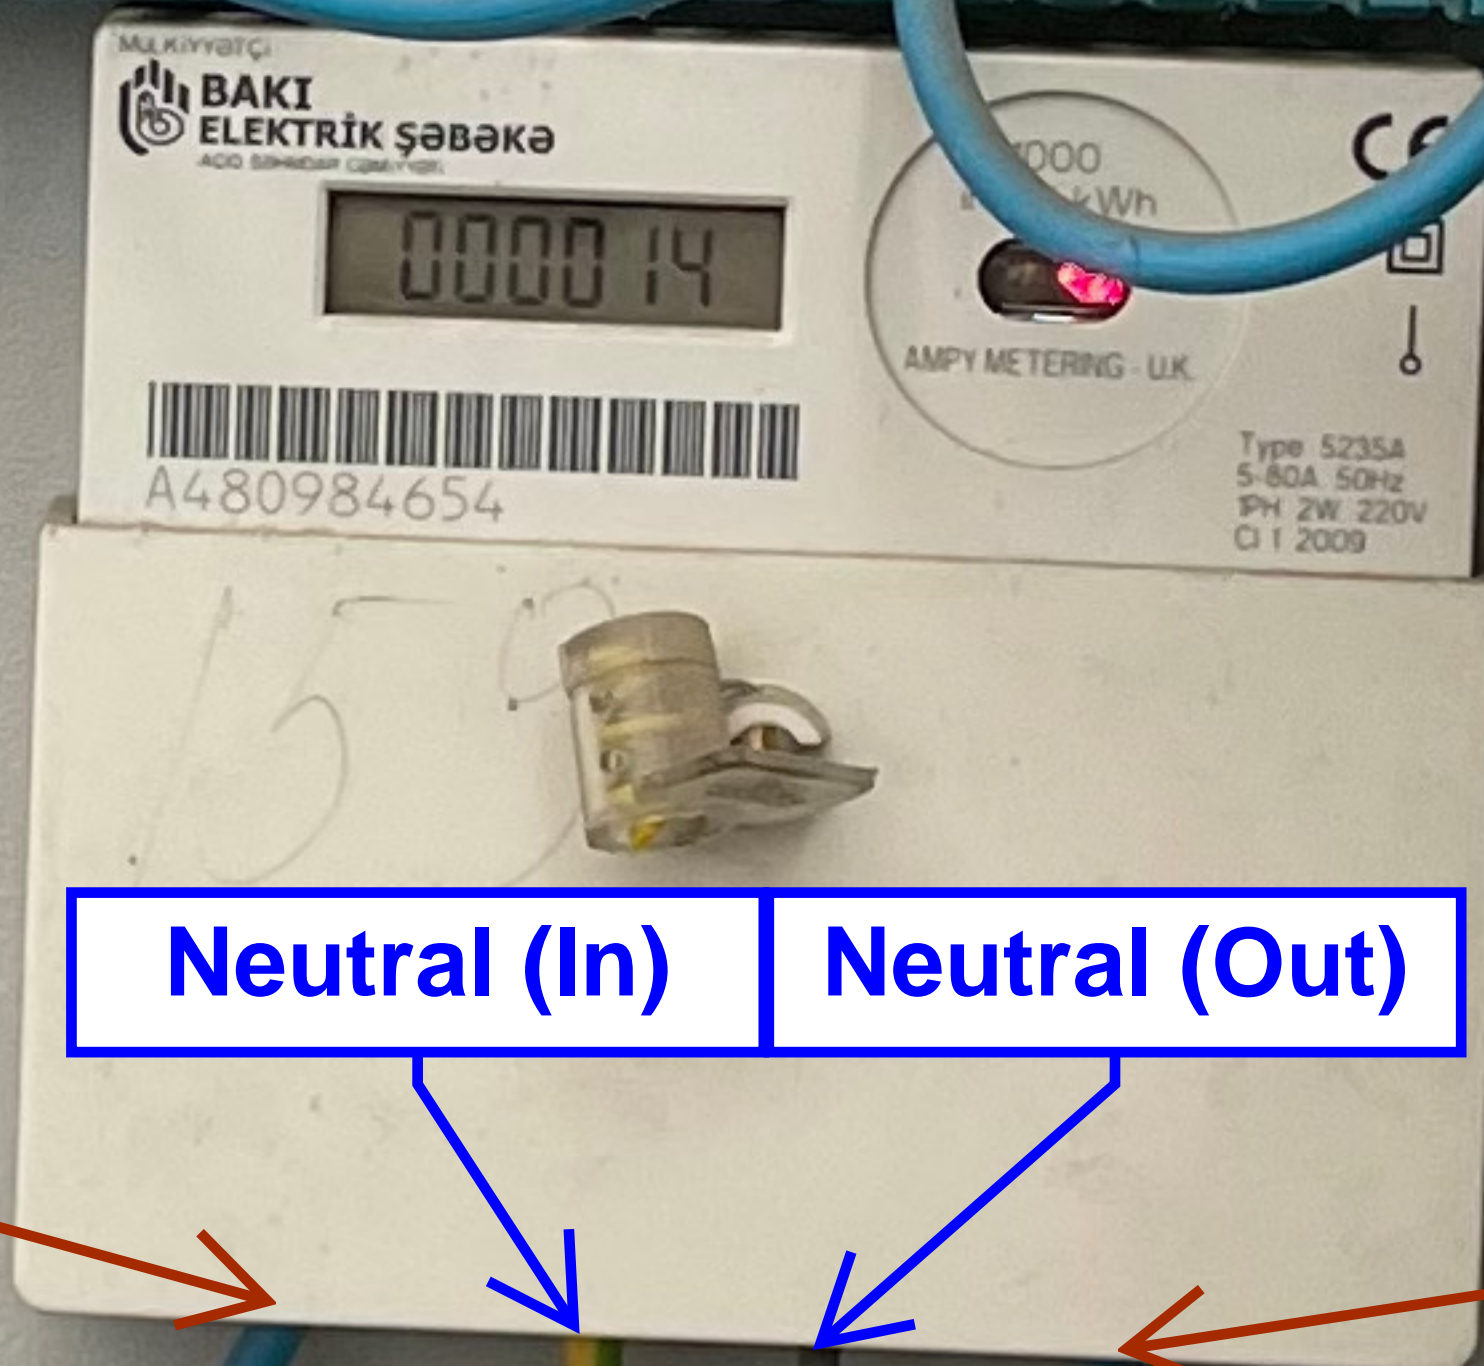
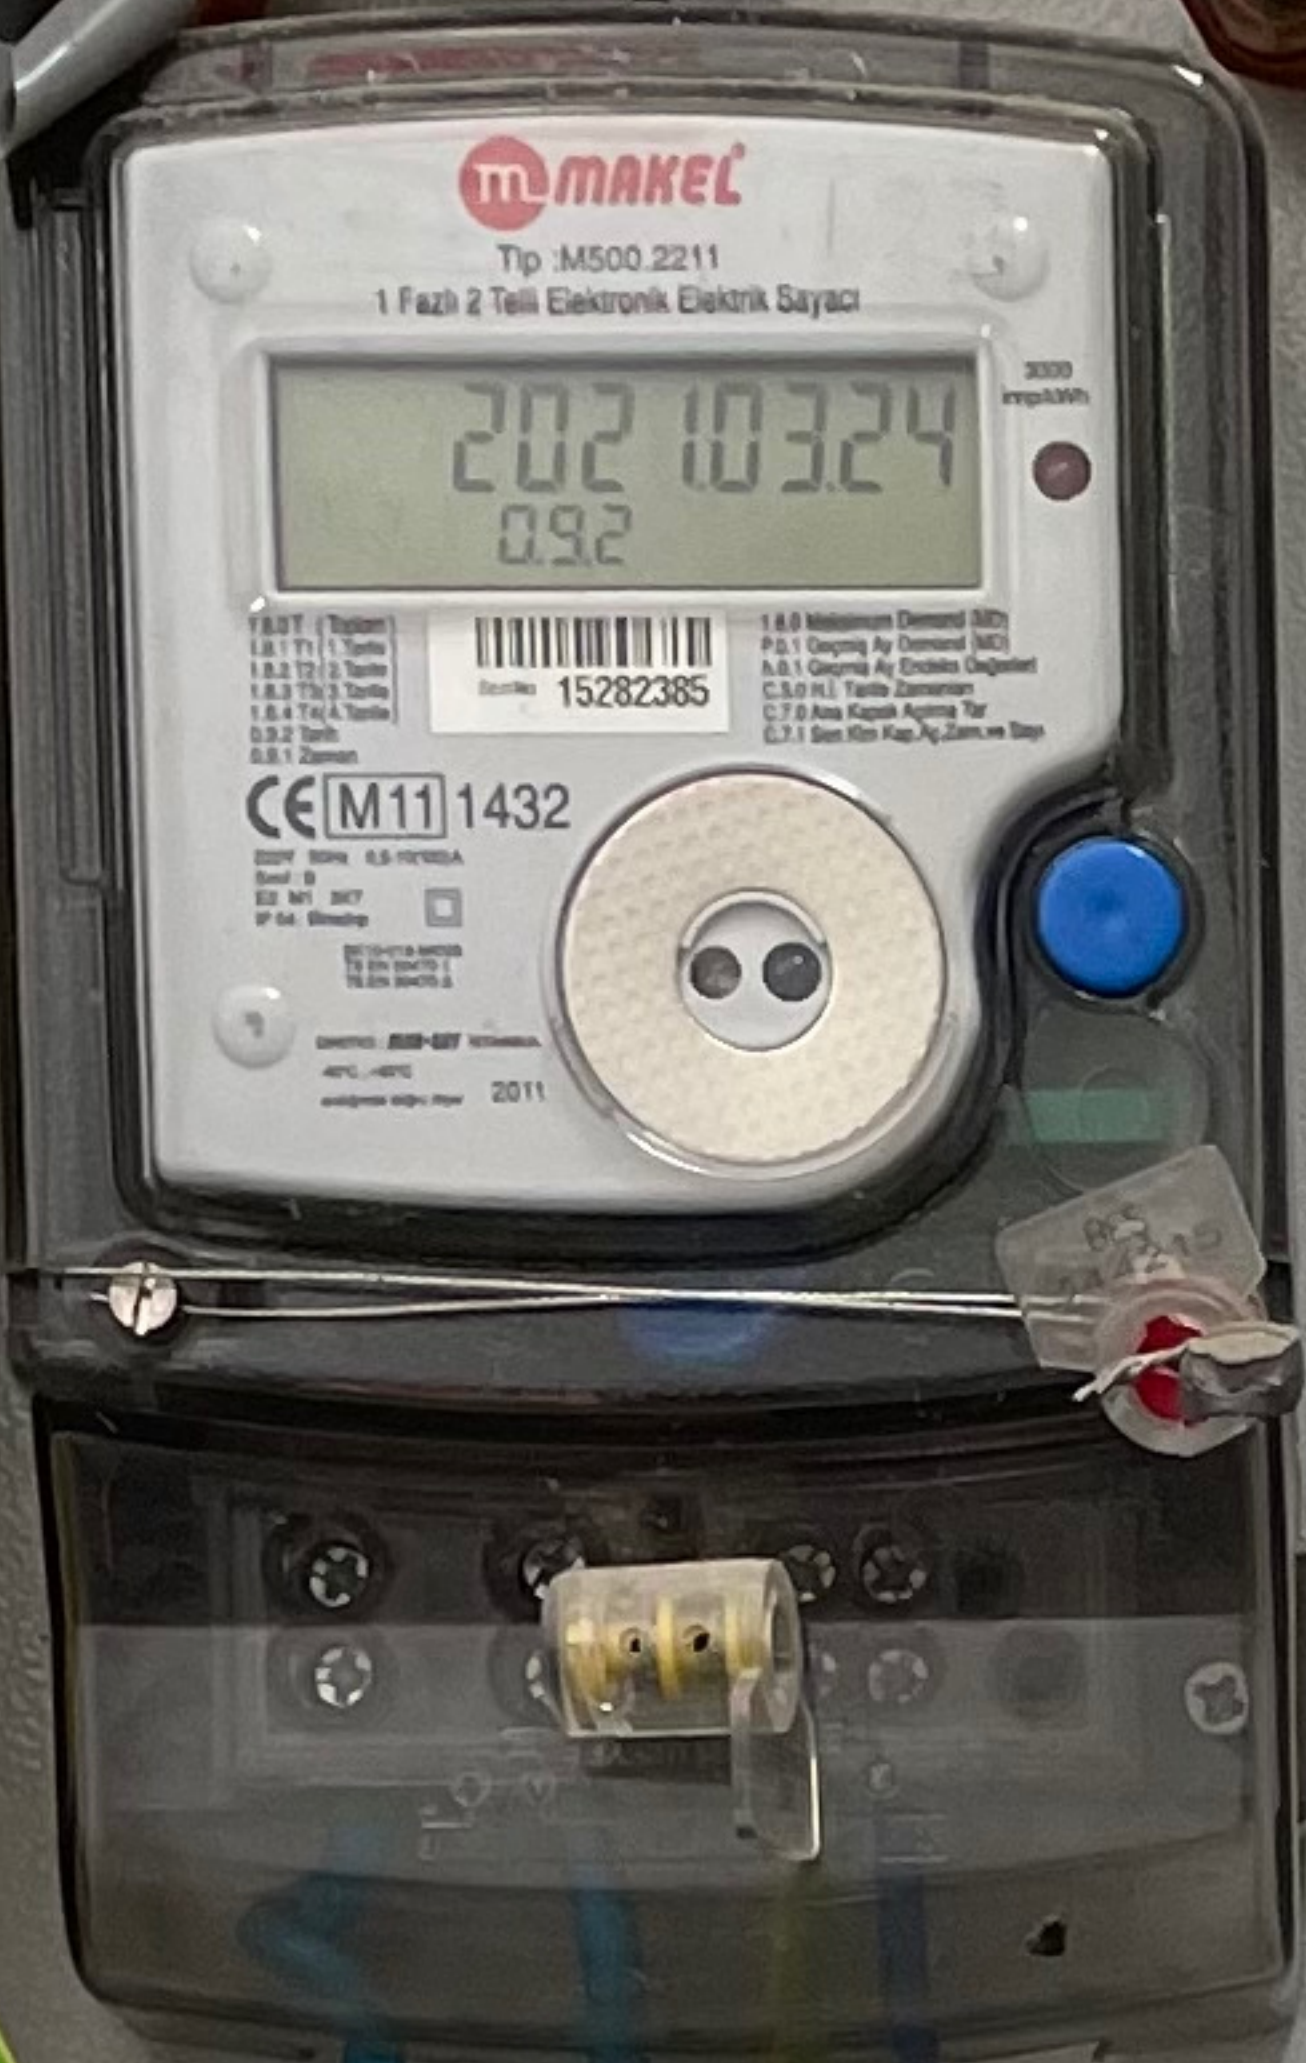
Plan to replace this cable. Not only does it have 2 apartments running through it, there is no CPC.

Earth connection cannot be verified. It is buried into the concrete floor however the rebar in the building may not be continuous... This is the only attempt at an earth I have found in this building block

There is no earth conductors / armoured cables anywhere in the building

Incoming 3-phase, 4-wire (3ph + N) supply Core colours are meaningless throughout (comes in and then out to more apartments in the block)
